**Addendum No. 1
Southeast Kentucky Industrial Development Authority
Speculative (Shell) Building #5 Construction
Southern Kentucky Business Park, Corbin, KY
Bid Date: September 5, 2023
Issue Date: August 29, 2023 – (2) 8.5x11 pages,
(1) 24x36 drawing.**

SOUTHEAST KENTUCKY
INDUSTRIAL DEVELOPMENT AUTHORITY, INC.
SOUTHERN KENTUCKY BUSINESS PARK
SPECULATIVE BUILDING #5
KNOX COUNTY, KENTUCKY

SITE GRADING & DRAINAGE

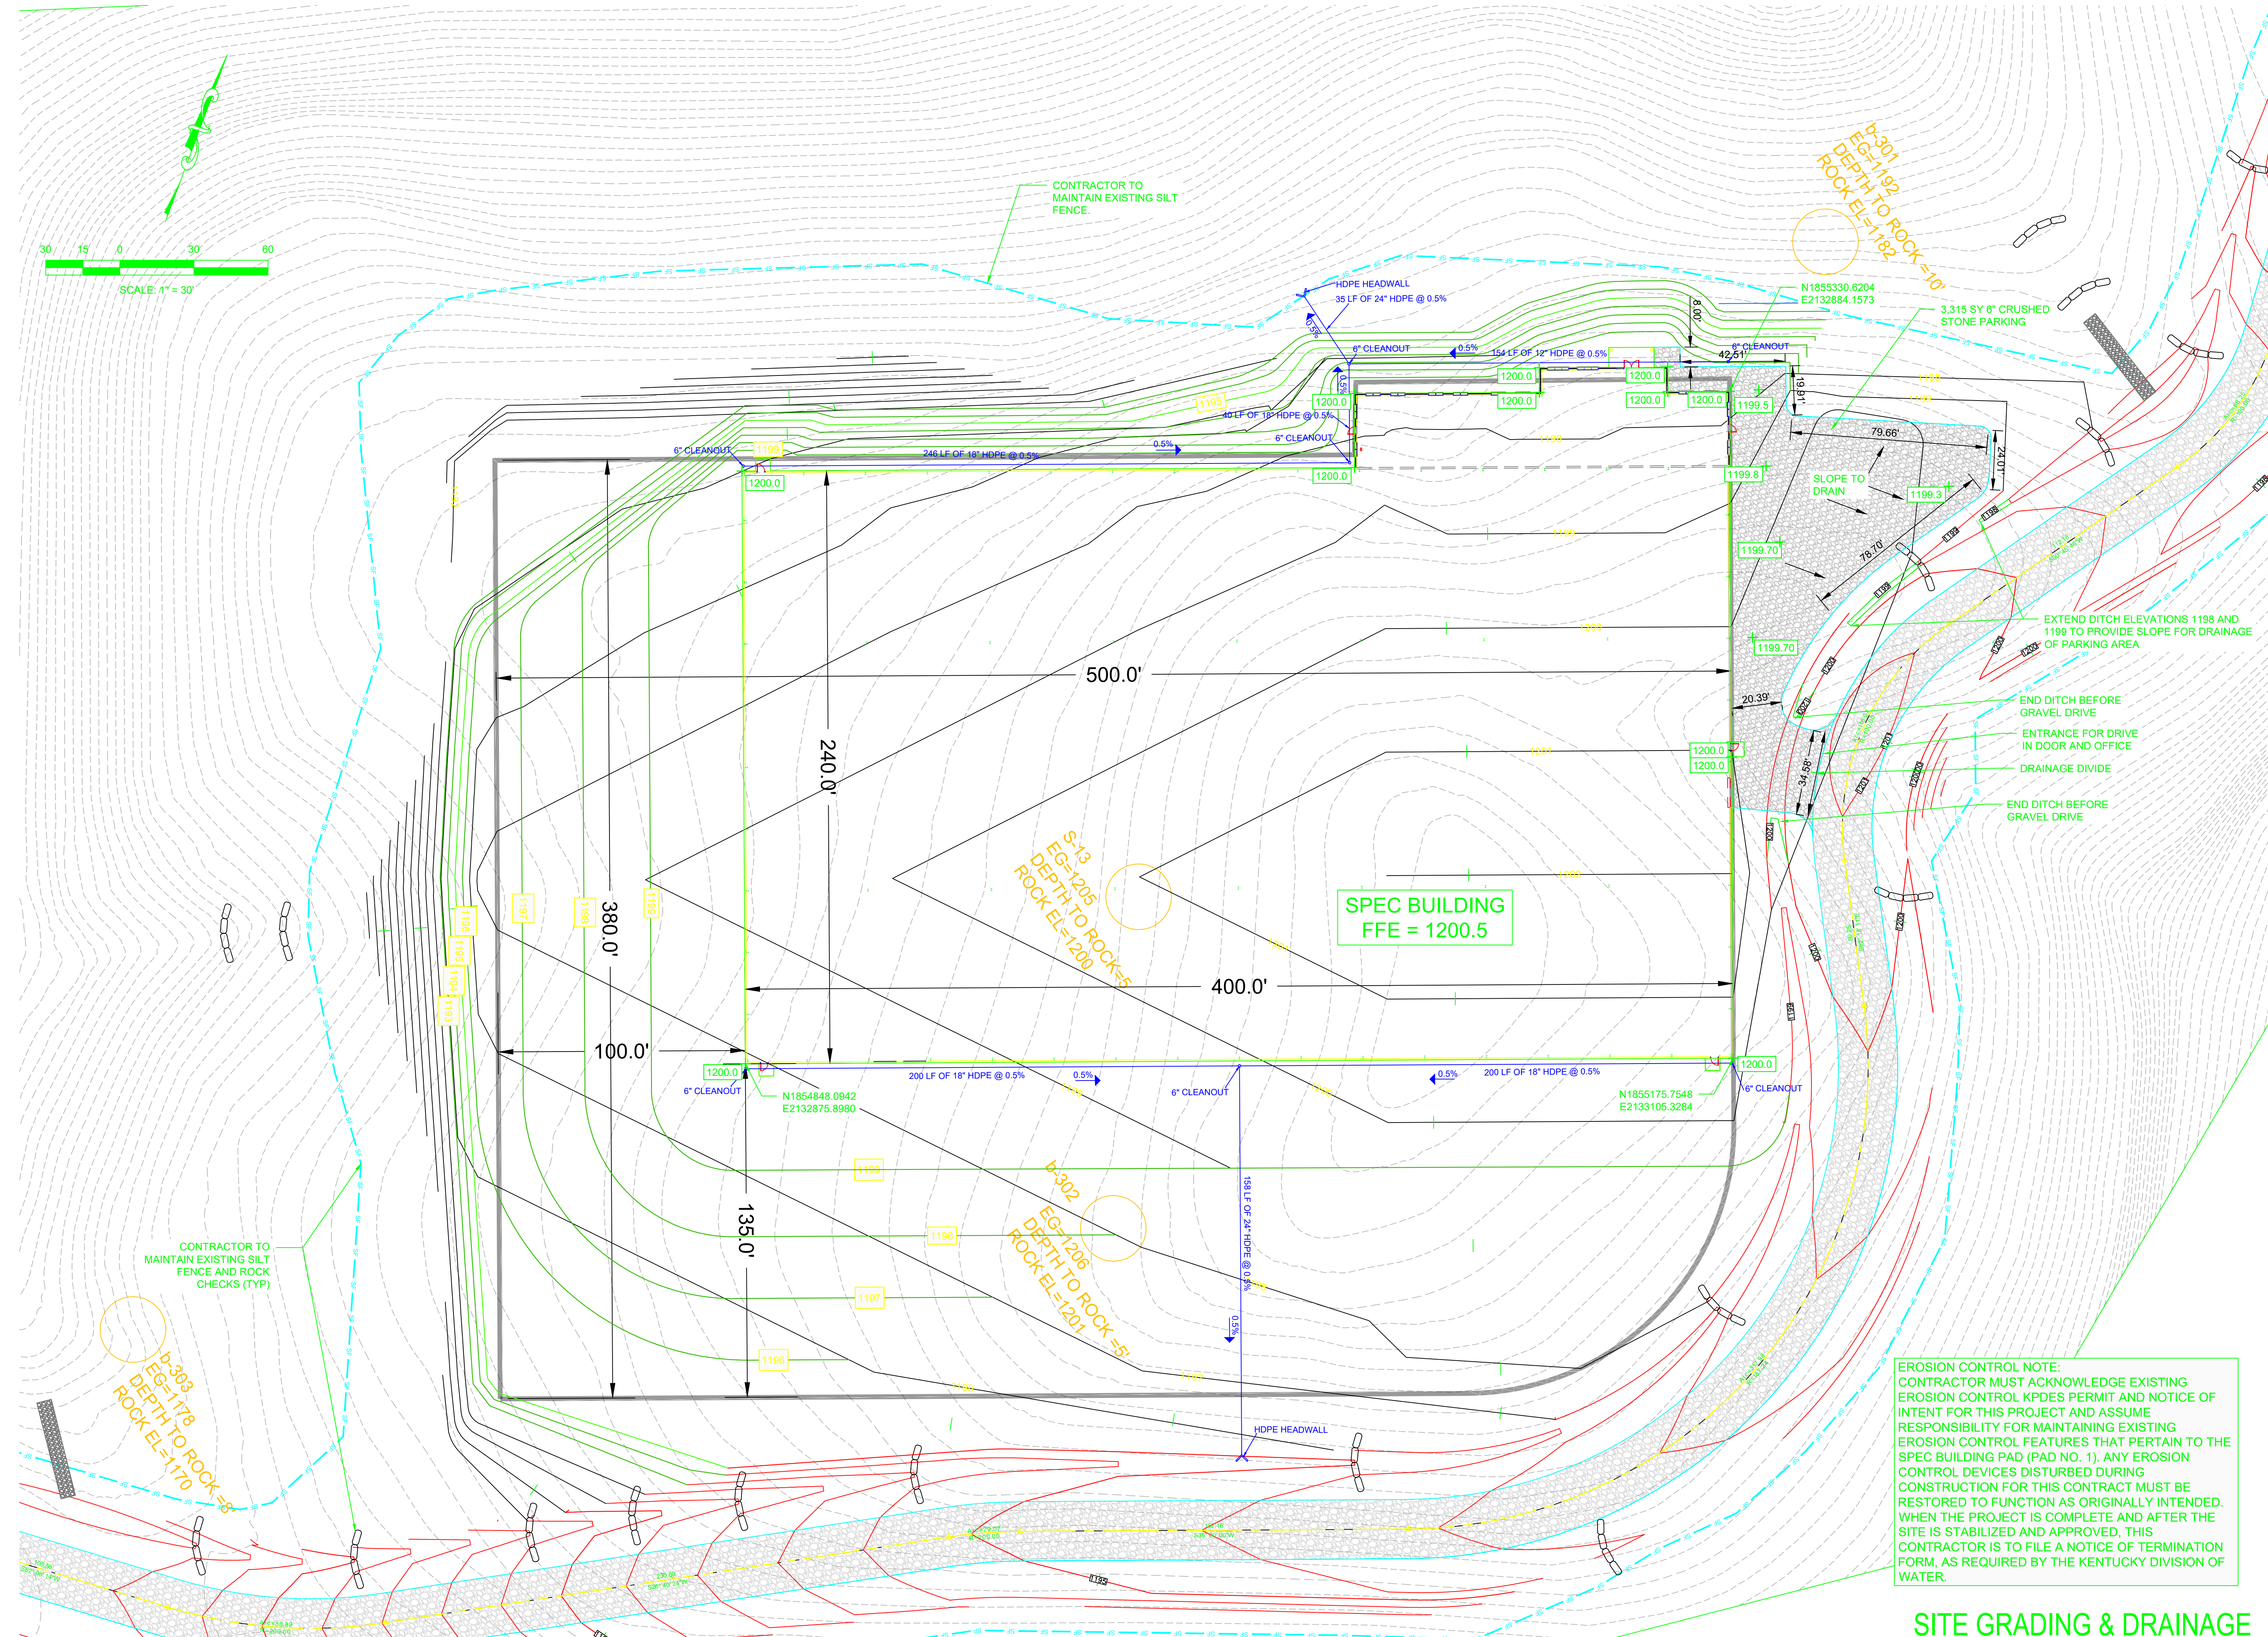
Item 3 – To clarify, the finished interior sub-base floor is a 10 mil vapor barrier (lapped and taped) over a 6” compacted stone base. Setup for a “future 6” concrete slab” not in project. FFE reference on C-1 of 1200.5 indicates that sub-base floor level will be 1200.

Item 5 - To clarify C-1 sheet, previously completed gravel road and road grading is existing, build ready pad grading is existing and existing erosion control is in place. New site work included in this project is to grade the build ready pad for the new Pre-engineered Metal Building, and maintain existing erosion control. A pre-bid meeting is not scheduled, but any interested Bidder is welcome to visit the site.

Item 14 - Attached herein is a revised Sheet C-1 with additional spot elevations around Front Office. We can send the CAD file via drop box, please contact MSE. Please note that there are 3 sets of contours in this file; the original ground before pad construction, the pad regrade design contours (not as-built) and the finish grade design contours for the spec building (_FG for bldg.). The existing pad contours are from plan design and are not as-built. Verification of the existing pad contours is at the discretion of the contractor
